PLANNING COMMISSION MEETING

**WHITE LAKE TOWNSHIP
PLANNING COMMISSION
FEBRUARY 5, 2026**

We have conducted a review of the final site plan dated February 6th, 2026 for the Lasting Impressions development. Our review of the preliminary site plan was conducted while the project was already engaged in the Township’s revise and resubmit process prior to our services being contracted for site plan review. For that reason, a full preliminary site plan report was not generated.

Site / Construction Plan Review

STORM SEWER PROFILE - ES 1 THRU BASIN TO CB 4

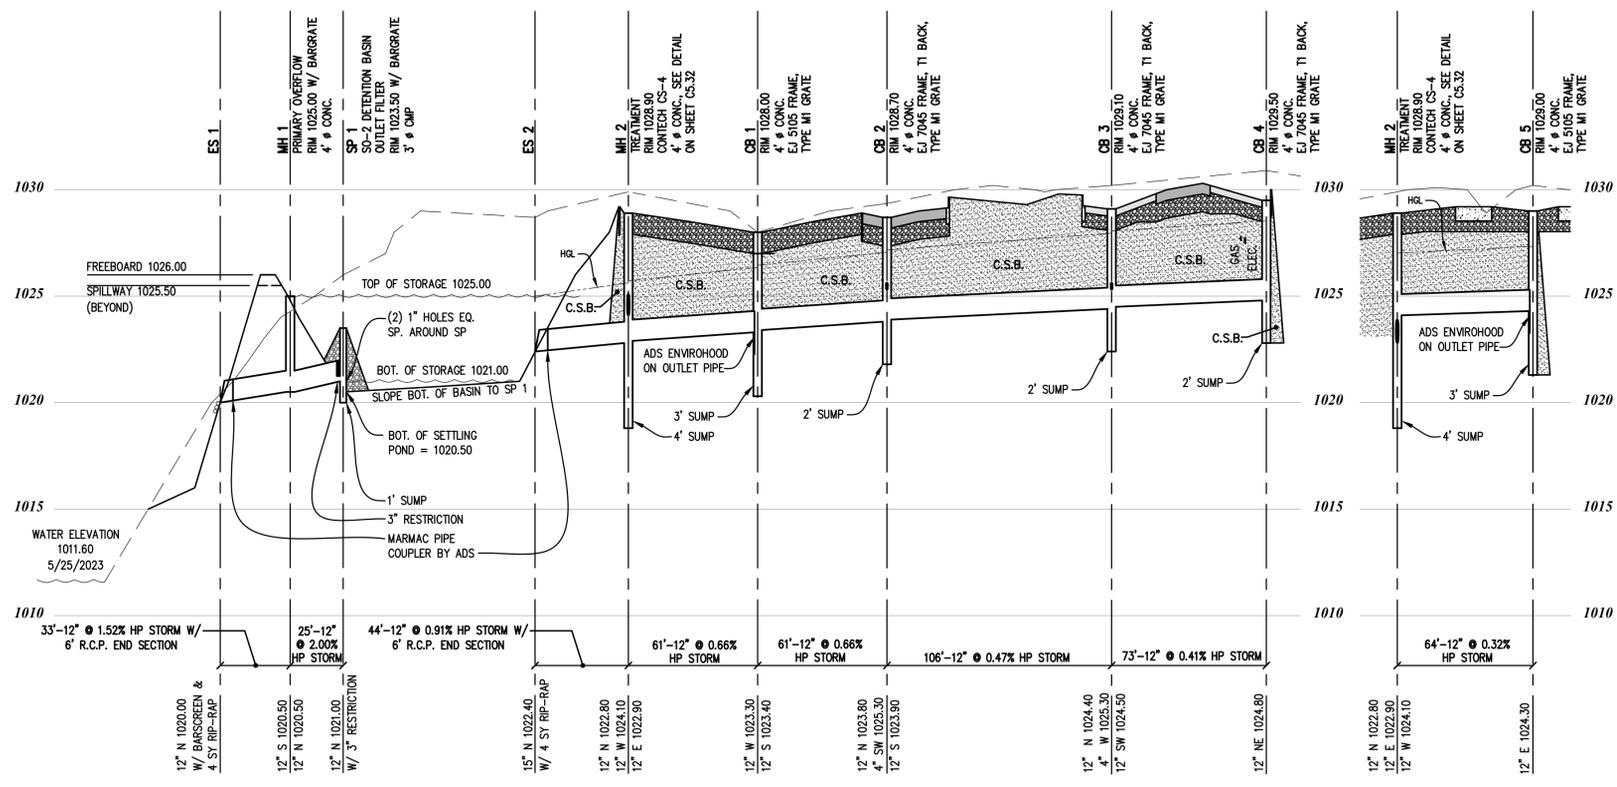
10. Sheet C3.31-Storm Sewer Calculations- 1) CB4 to CB3- Revise 'Rim or Grade' to 1029.50; 2) CB3 to CB2- Revise 'Rim or Grade' to 1029.10. **Comment addressed. Rim elevations fixed.**

11. Sheet C3.31- Show HGL on profiles or provide in Storm Sewer Calculations table. **Comment addressed. HGL displayed.**
12. Sheet C3.31-1) Profile ES1-MH1- Footage of pipe (27') does not match Sheet C1.31 (33'); 2) Profile ES2-MH2- Footage of pipe (38') does not match Sheet C1.31 (44'). **Comment addressed. Pipe footage changed.**

SHEET NUMBER: L1.01

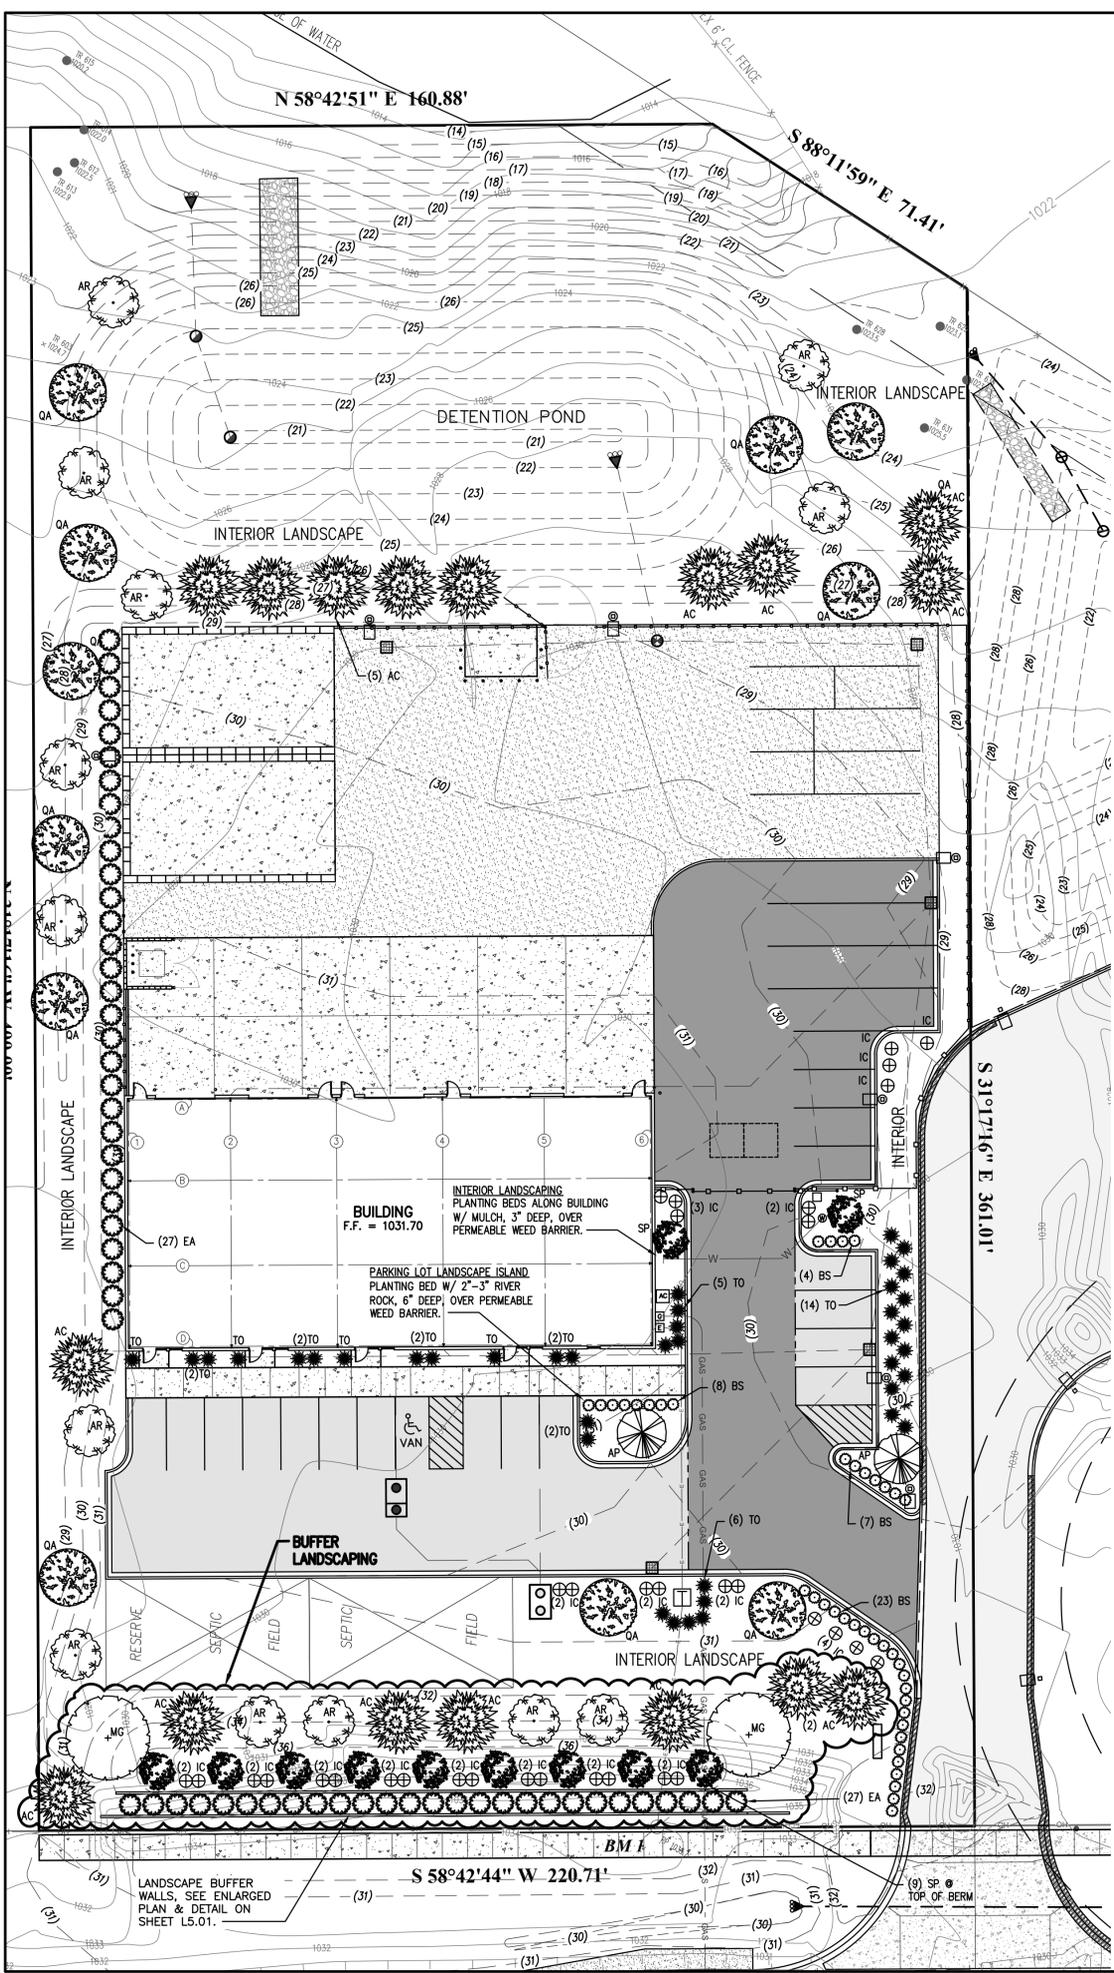
14. Sheet L1.01- There are a few areas where proposed trees shall be shifted to maintain horizontal separation between trees and proposed storm sewer and sanitary lead. Please see attached marked up plan sheet for locations. **Comment addressed, plans have been updated to address markups.**

Section 5.19.B outlines general provisions for site landscaping. No trees may be planted closer than four (4) feet from any property line. While distance dimensions were not provided, a note should be added to Sheet L-1.01 indicating this requirement will be met.

Sheet L-1.01 provides interior landscaping calculations. The shrub counts are short of requirements. 123 shrubs will be required to meet standards or a waiver will be required.

- 1. A note should be added to Sheet L-1.01 indicating no trees shall be planted within four (4) feet of any property line.*
- 2. Planning Commission to consider wavier for ROW greenbelt consisting of a terraced landscape wall.*
- 3. Planning Commission to consider waiver to allow 95 interior shrubs instead of the required 218 shrubs.*
- 4. Public Safety should review and approve the proposed access via the powered gate to the rear yard.*
- 5. It is unclear if the gate will obscure view into the rear yard. This should be clarified to ensure views into the storage area are screened.*

SHEET NUMBER: L5.01

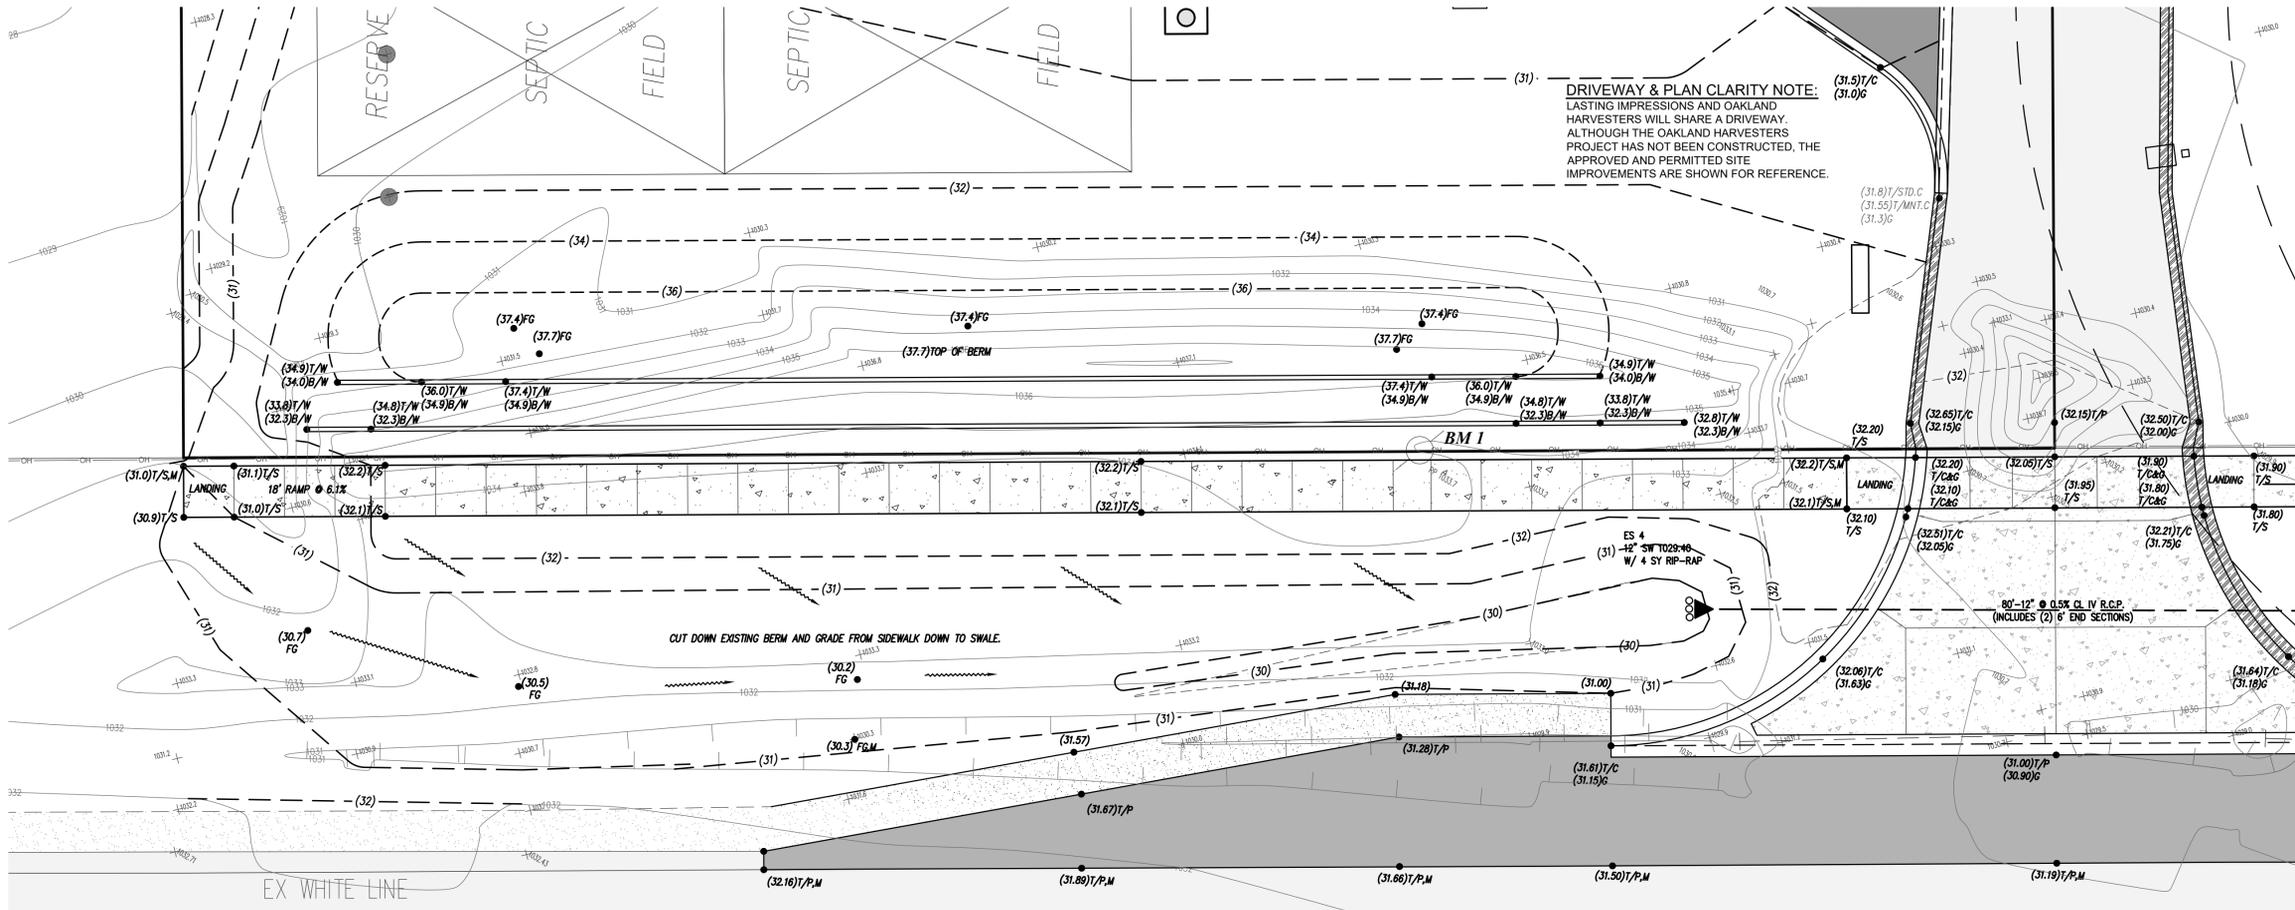
8. Sheet L5.01-Upper proposed retaining wall- Both ends: 34.0T/W and 34.9B/W grades seem reversed. Please clarify. **Comment addressed. Grades have been updated.**

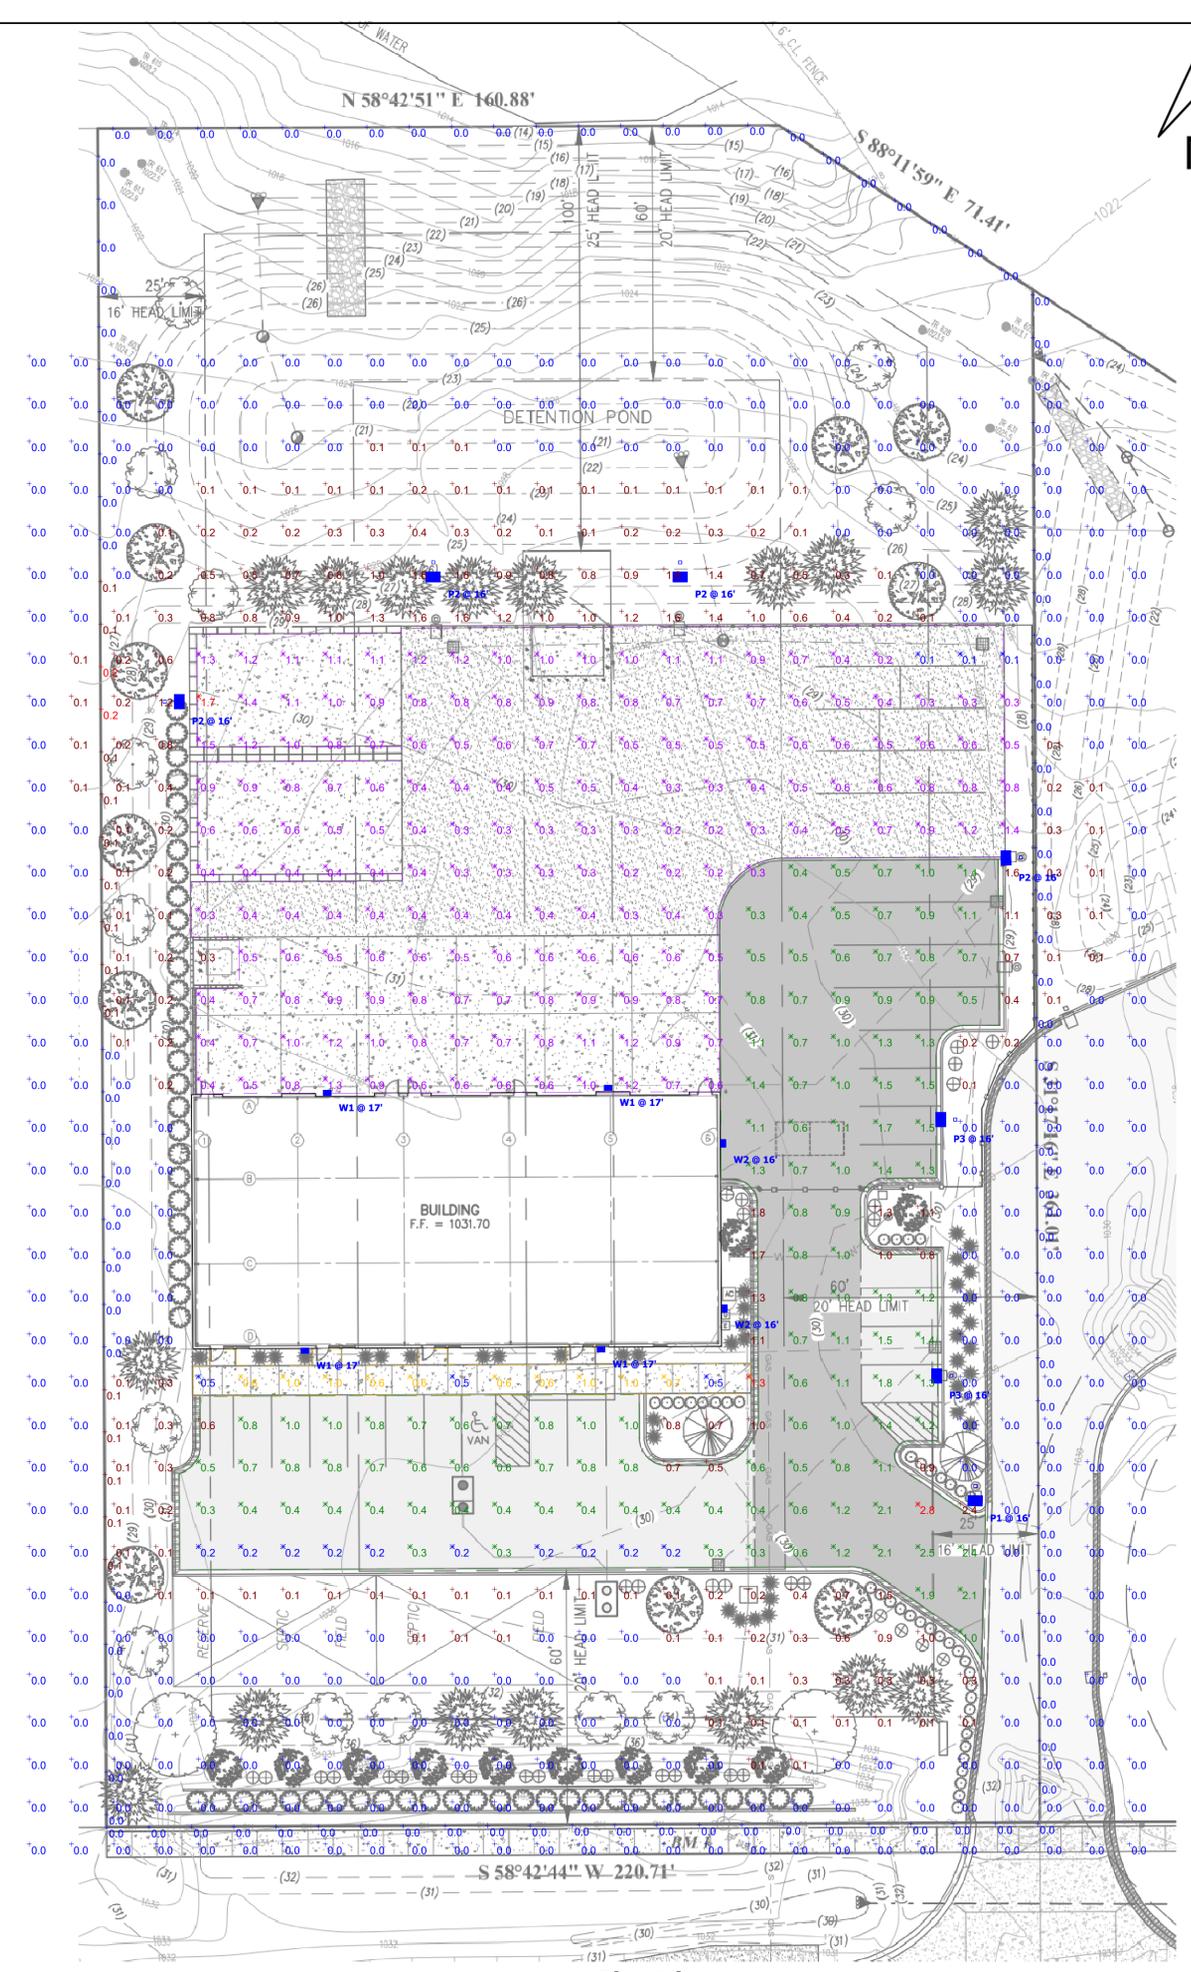
Pole lighting shall not be closer than five feet to a property line. The distance between the light poles and adjacent property lines should be added to the lighting plan. All other standards have been met.

Items to be Addressed: *The distance between the light poles and adjacent property lines should be added to the lighting plan.*
